METROPOLITAN GOVERNMENT OF NASHVILLE AND DAVIDSON COUNTY

Metropolitan Historic Zoning Commission
Sunnyside in Sevier Park
3000 Granny White Pike
Nashville, Tennessee 37204
Telephone: (615) 862-7970
Fax: (615) 862-7974

STAFF RECOMMENDATION
3616 Westbrook Avenue
April 16, 2014

Application: New construction-addition
District: Richland-West End Neighborhood Conservation Zoning Overlay
Council District: 24
Map and Parcel Number: 10405022000
Applicant: Gilbert McLaughlin Casella Architects, PLC
Project Lead: Paul Hoffman, paul.hoffman@nashville.gov

1 SOUTH ELEVATION (FRONT)
 SCALE: 1/8" = 1' - 0"

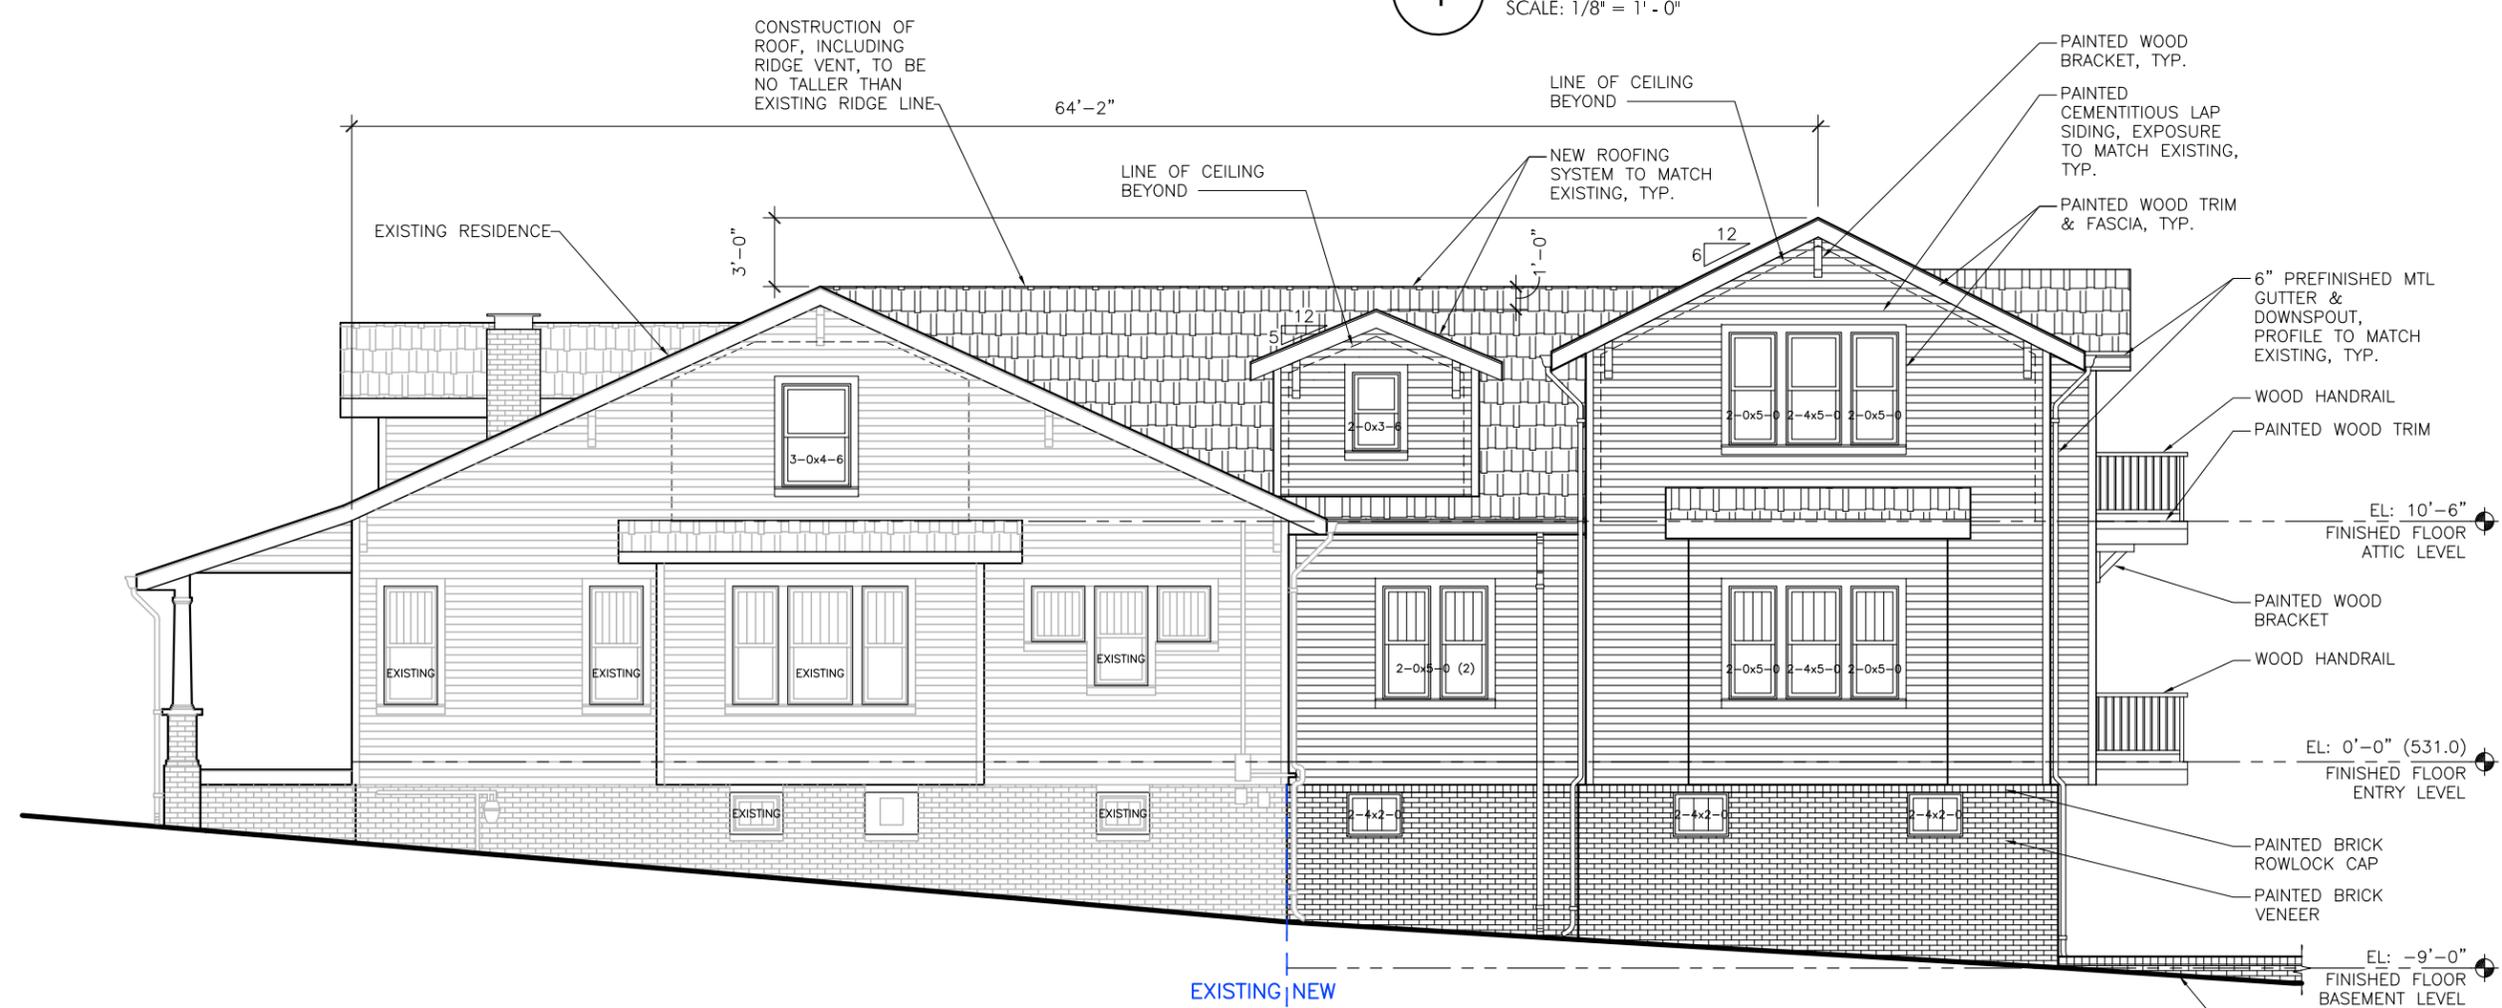
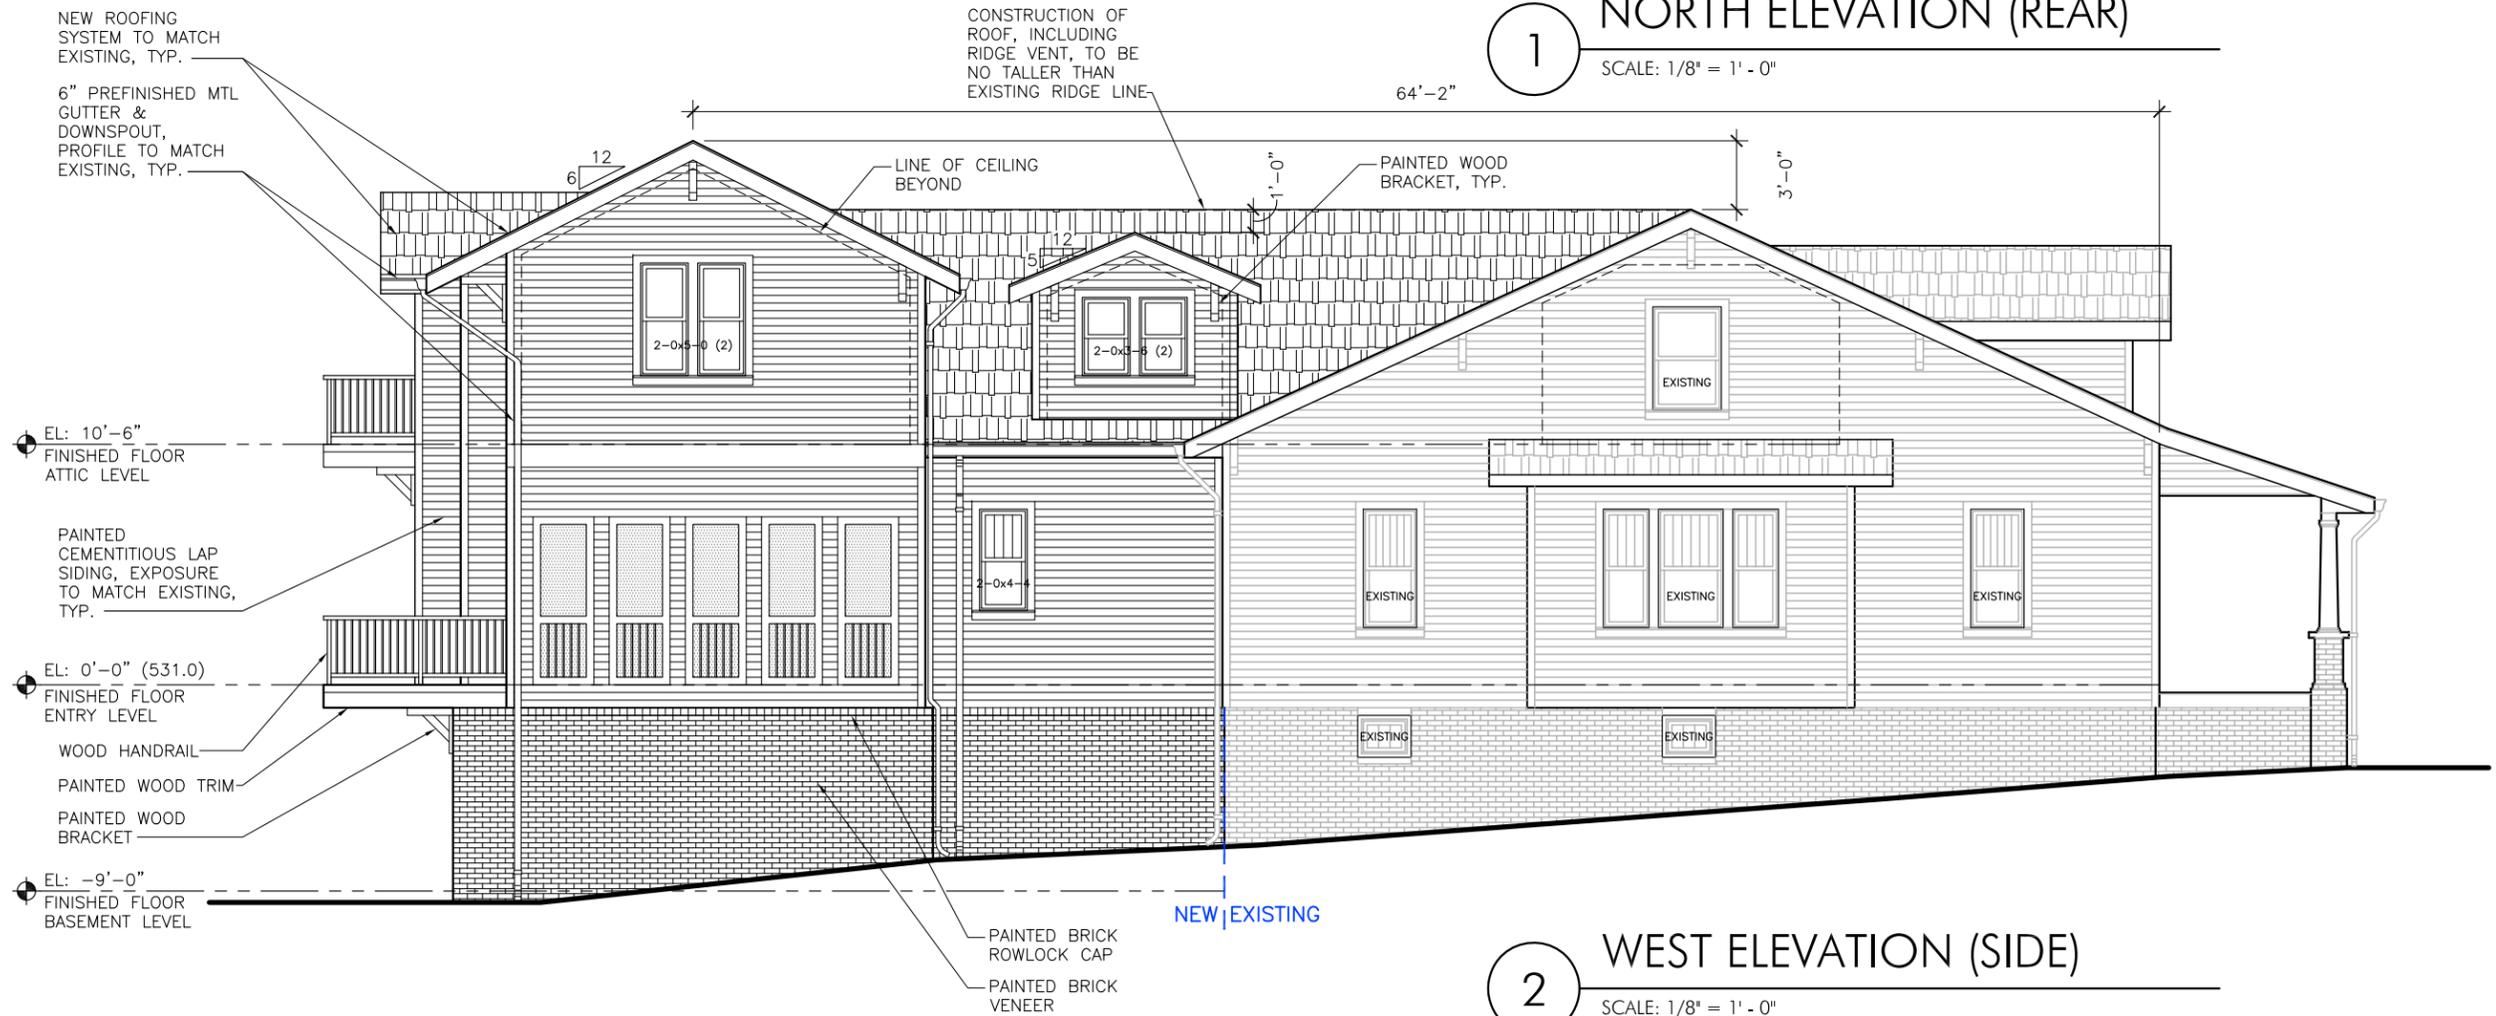
Drawings indicate no major changes to the materials of the historic house. The addition has a concrete block foundation with brick veneer. Staff asks to review a brick sample. The addition will be clad in cement fiber lap siding with a reveal matching the existing

siding. The windows were not specified, and staff asks for final approval of windows prior to their purchase and installation. Doors and garage doors also were not specified. The screened porch has a concrete slab on the stone foundation with wood box columns supporting the screen frames. Roofing shingles will match the existing. With the staff's final approval of the brick, windows, doors and garage doors, staff finds that the known materials meet section II.B.1.d and II.B.2.

The addition has a cross-gabled roof with 6/12 pitch and gabled dormers also with 6/12 pitch. The gabled form and pitch are common among surrounding historic buildings. The project meets section II.B.1.e and II.B.2.

Recommendation Summary: Staff recommends approval with the condition of final approval of a brick sample, windows, doors and garage doors prior to their purchase and installation and with the condition that the HVAC be located on the rear façade, or on a side façade beyond the midpoint of the house.
